Planning Commission Meeting

September 12, 2023 6:00 PM

4.I. 558 Woodrow Avenue Site Plan Review

DATE: August 24, 2023
TO: Adrienne Senter
FROM: Lynn Patterson
RE: Site Plan Review – 558 Woodrow Ave

3
2A-1
WEST ELEVATION (RIGHT)
SCALE: 1/4" = 1'-0"
GRAPHIC SCALE

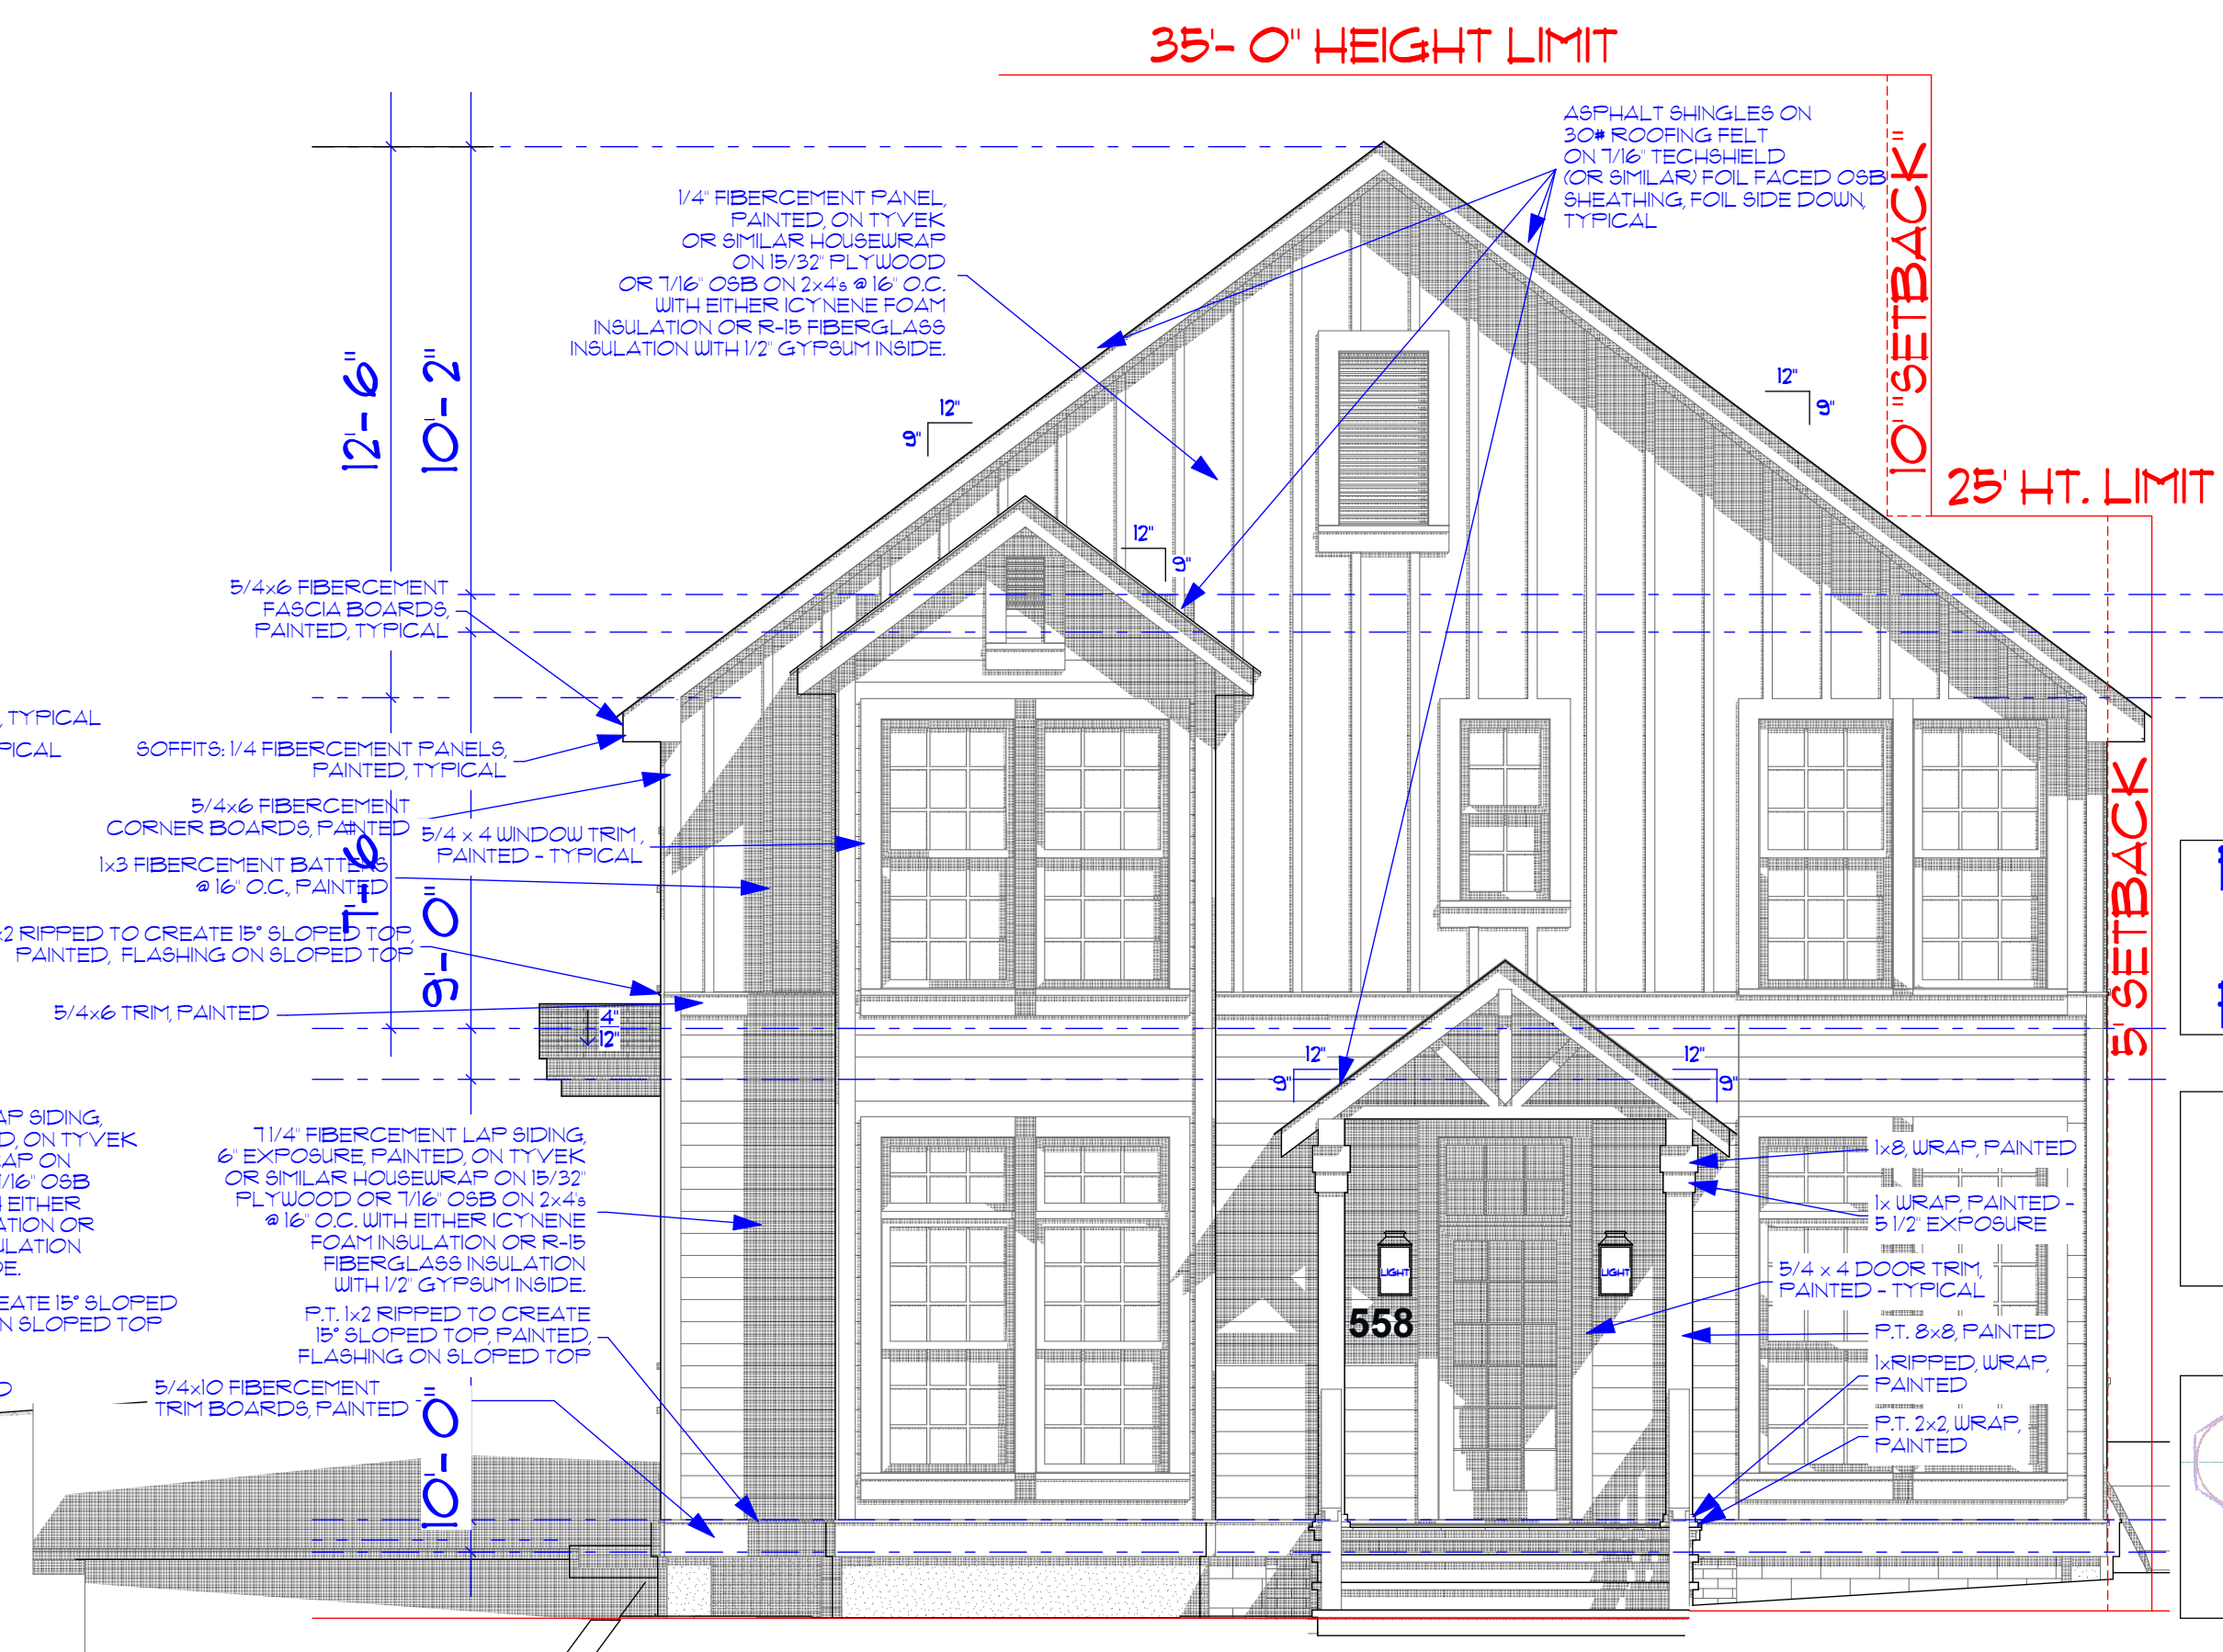
The City of Hapeville has received a site plan application from Avuntee Patel to construct a 2,319 SF single family residence at 558 Woodrow Avenue. There is an existing house which will be demolished to the foundation. The proposed dwelling has 4 bedrooms and 4 ½ baths. The height of the residence is not provided from the foundation to the front ridge (see 2A-1 North Elevation).

- ***The proposed new single family dwelling is shown as below the 35' limit from the front grade. Please provide actual dimension from grade.***
 - b. The location and general design cross section characteristics of all driveways, curb cuts and sidewalks including connections to building entrances.

- *Provide dimensions for concrete driveway including width, length, and length beyond front façade of house.*
- *Show the existing sidewalk on the site plan.*
- *Provide actual height from grade*
- *Provide front, side, and rear setback dimensions of house. Include front stoop/concrete steps as closest point for the front and eaves to the side and rear.*
- *Provide confirm eaves are not in the setback.*
- *Confirm if any on site grading will be done.*
- *Show rear setback dimensions.*
- *Provide a tree conservation plan.*
- *Provide a development schedule.*
